SUBMISSION FOR APPLICATION No. SSD5752

Please find the submission below that OBJECTS to the current Development Application SSD5752.

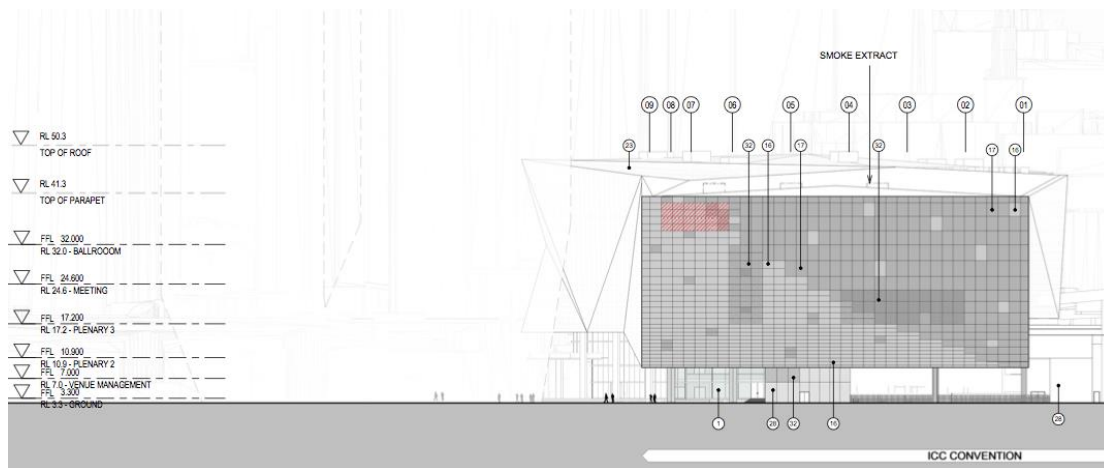
We firstly object to the height of the proposed new ICC convention centre which is nearly to the top of the Goldsbrough's current height.

In the DA plans the proposed height is RL 50.3 which will block the entire view to Darling Harbour and the city from the Goldsbrough's eastern facing apartments. There is supposed to be a concept of view sharing in the city but in this case the whole of the eastern view of the Goldsbrough will be blocked out by the new ICC convention centre.

In place of the current city skyline and Darling Harbour view there will be a flat blank metallic wall in its place, which is the rear of the proposed ICC convention building. The front of the ICC building looks to be nicely designed with glass and is broken up in angles, but the Goldsbrough will be facing an ugly flat back wall made of aluminum and mainly Grey.

Please see the diagram of the back of the ICC convention centre below , which will be approximately the same height as the Goldsbrough.

This is the walkway being removed

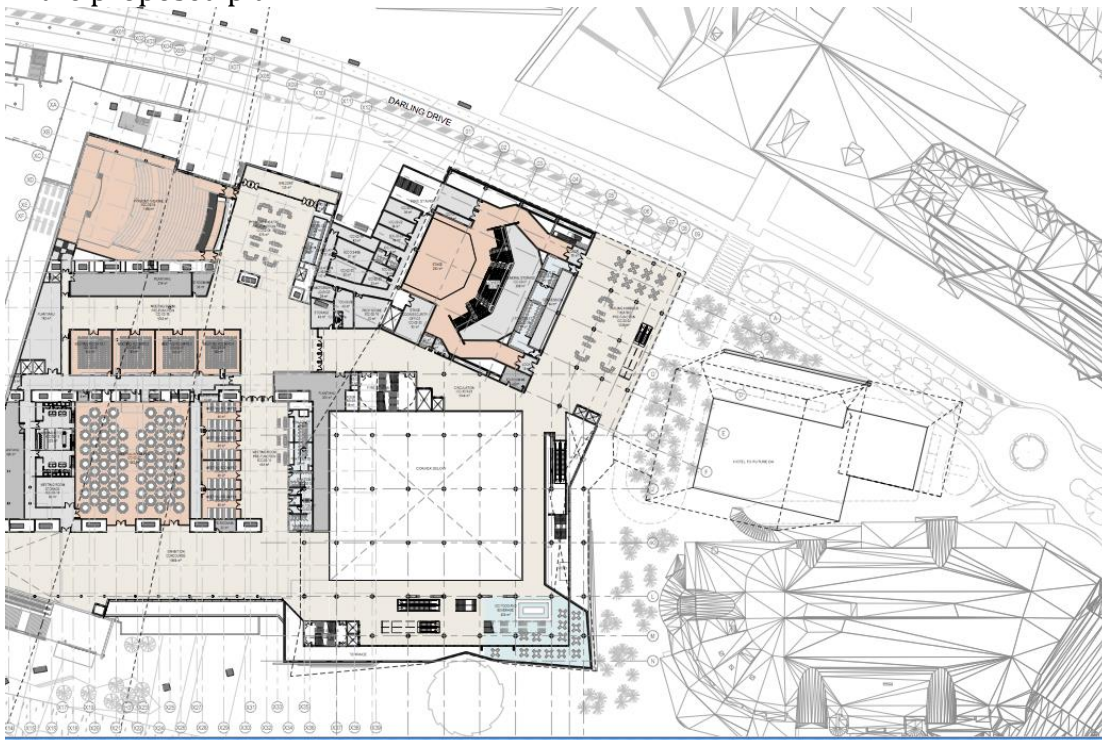
The proposed changes at Darling Harbour seem to take away an extremely important thoroughfare for the residents and guests of the Goldsbrough. From the plans it looks like the current overhead pedestrian walkway next to the Convention monorail station is being removed. Currently it is the easiest and safest walkway to enter the Darling Harbour precinct from the Western side.

If this entry to Darling Harbour is removed it will be a total disaster for many of the pedestrians who regularly use it as well as visitors to the area. Currently it is estimated that there are around 7000 pedestrian traffic movements across this walkway on a regular day and many more on busy event days. It is the only safe way to cross the light rail tracks and Darling Drive and is the direct access for 2 major carparks servicing Darling Harbour. This walkway is open 24 hours a day, 7 days a week with continuous public access.

The alternative link from the Western Distributor is not a convenient alternative to what is currently there. How are pedestrians especially with children meant to cross to and from Darling Harbour in a safe way at all hours ?

From the Architectural drawings below it shows how the current walkway is removed in the proposed plan

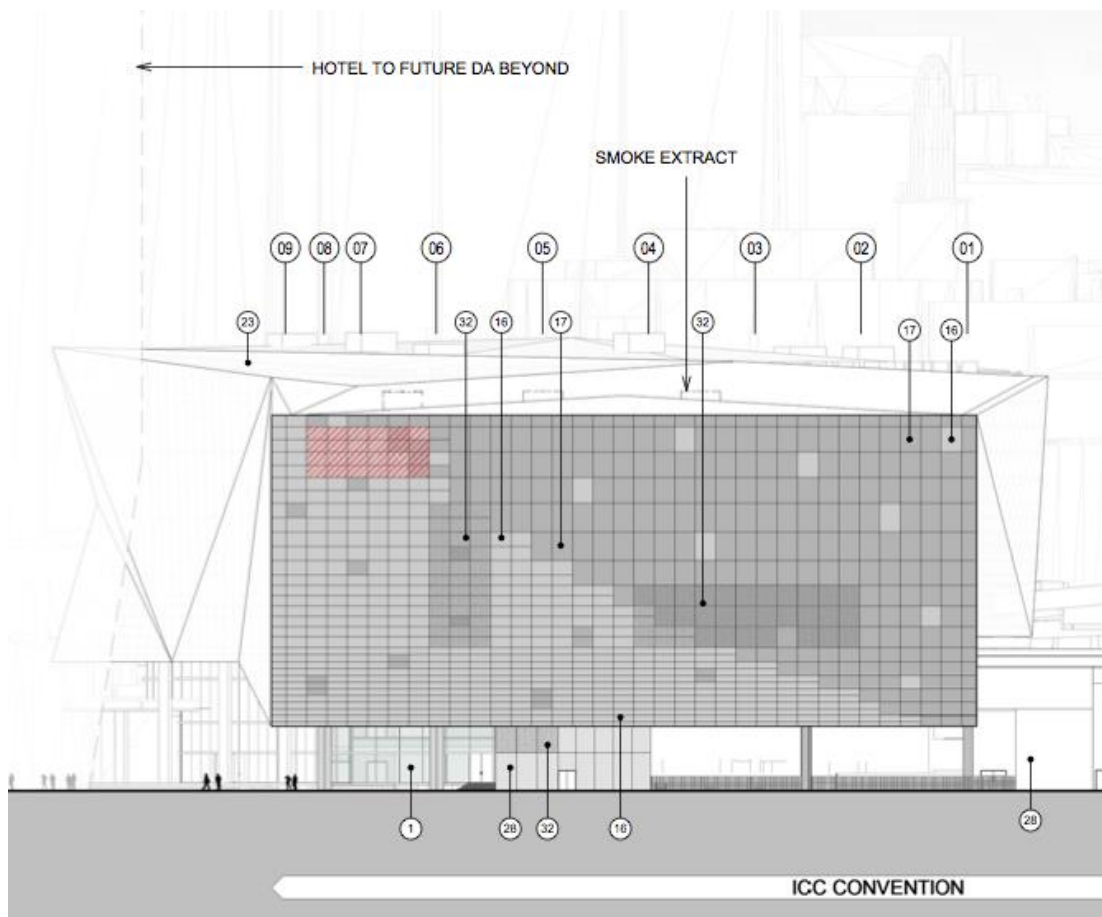
As the height of the proposed ICC is nearly the current height of the Goldsbrough, any outlook from the Goldsbrough to Darling Harbour will be dominated by the Western (rear) face of the ICC.

In the DA plans it shows that this will be a mainly Grey metal panel wall which will just look like a Grey metal barricade from the Goldsbrough. All the architecturally appealing glass frontage is kept for the Eastern (Darling Harbour facing) face of the building. All the publicity shots show the view of the East face yet all the Goldsbrough will see is the ugly utilitarian Western face.

If the view from the Goldsbrough is to be dominated by the ICC then at least some regard should be paid to the fact and the Western face of the ICC modified to be more aesthetically appealing. The western face could be architecturally articulated and made of materials that don't look like a metal barricade.

See Diagram below for view of the Western face of the ICC facing the Goldsbrough. Note the scale of this wall in relation to the people in the picture.

Measures such as changing the form and materials of this Western wall should be urgently considered. With a different use of materials, reshaping and clever use of lighting , this face need not be such an eyesore that will dominate most of the resident's views.
